Klamath River Dam Removals – Team Review of A/E Study

Klamath Hydroelectric Project
FERC License No. 2082
Oregon - California

U.S. Department of the Interior
Bureau of Reclamation
Technical Service Center
Denver, Colorado

February 17, 2009

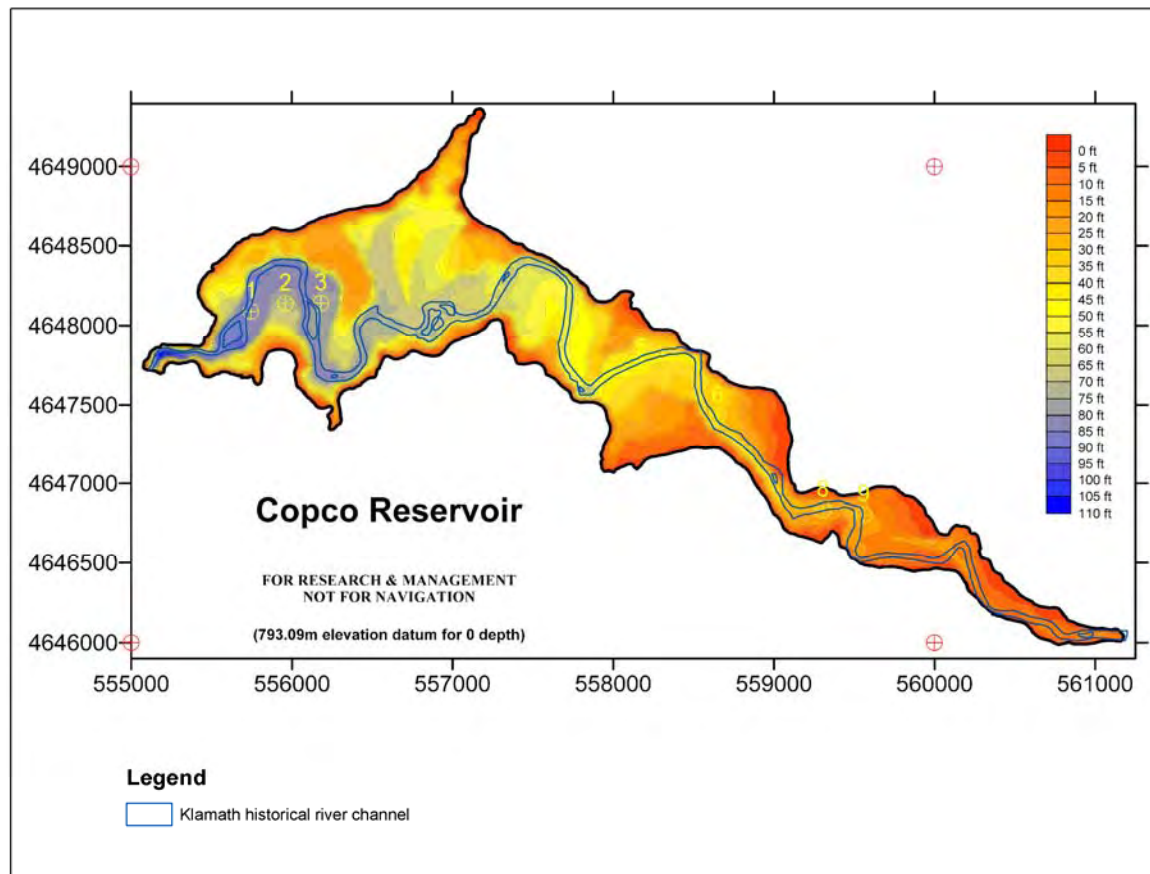
The Team does not believe that the duration of sediment impacts is well understood at this time. The GEC report seems to assume that water quality impacts will be isolated to the reservoir drawdown period. The only additional erosion of reservoir material is assumed to occur during subsequent high flow events with already high sediment concentrations. However, the sediment concentrations may be higher than background concentrations for a longer period of time than assumed by the GEC report. The reservoir material was assumed to obtain stable 10:1 slopes in a relatively short period, but it may require several months to drain the reservoir sediment, and continual sloughing of material into the channel may occur after the initial drawdown for an extended period of time. This was observed at Lake Powell during the spring of 2004, when even after the reservoir elevation had stabilized following a drawdown, bank erosion continued to occur because of the low strength of the reservoir sediments. Shannon and Wilson (2006) state: "For planning purposes, to estimate sediment volume eroded from the

reservoir following initial rapid drawdown and the first winter storms, we recommend assuming that soil will erode above surfaces projected at 10 horizontal to 1 vertical (10H:1V) upward from the projected stream edge. However, it is likely that all of this material will not mobilize during the first winter it is exposed. Additional studies to attempt to quantify erosion impacts beyond the first season may be required.” The Team concurs with these statements and believes that suspended sediment concentrations will be significantly elevated downstream of the dams for up to one year. Further analysis of the detailed erosion and drainage characteristics of the sediment needs to be performed if less conservative assumptions are made. Currently, GEC is taking a conservative approach to estimate sediment volumes, but the Team believes GEC is not taking a conservative approach in estimating the duration of elevated sediment concentrations downstream. It is uncertain if their final estimate of downstream sediment impacts is accurate or conservative. The Team believes that reducing the uncertainty in the volume of sediment and pre-dam surface would cost a relatively small amount and improve the ability to estimate sediment impacts and plan dam removal schedules and mitigations.

It was also assumed by GEC that the river channel would immediately find the pre-dam channel. Based upon the reservoir topography map, the current deepest point generally follows the historical pre-dam channel (see figure of Copco No. 1 Reservoir below for an example). However, there may be some locations where this does not occur. The initial channel may form in a different location than the pre-dam channel. As the channel works its way to the pre-dam channel, it will erode additional reservoir sediment. If the above scenario occurs, the duration of downstream impacts could be extended past the initial drawdown period. In another scenario, the river finds the historic channel immediately but, because the sediments are fine and cohesive, the sediments drain slowly and as they drain the sediments slough off into the channel. The impacts from either of these scenarios may still be acceptable, but the Team believes that there has not been sufficient analysis to discount these possibilities. The Team recommends that a more accurate pre-dam surface be developed. Also, the draining characteristics of the sediment should be quantified because it may take much longer than GEC assumed for the reservoir sediment to drain and stabilize.
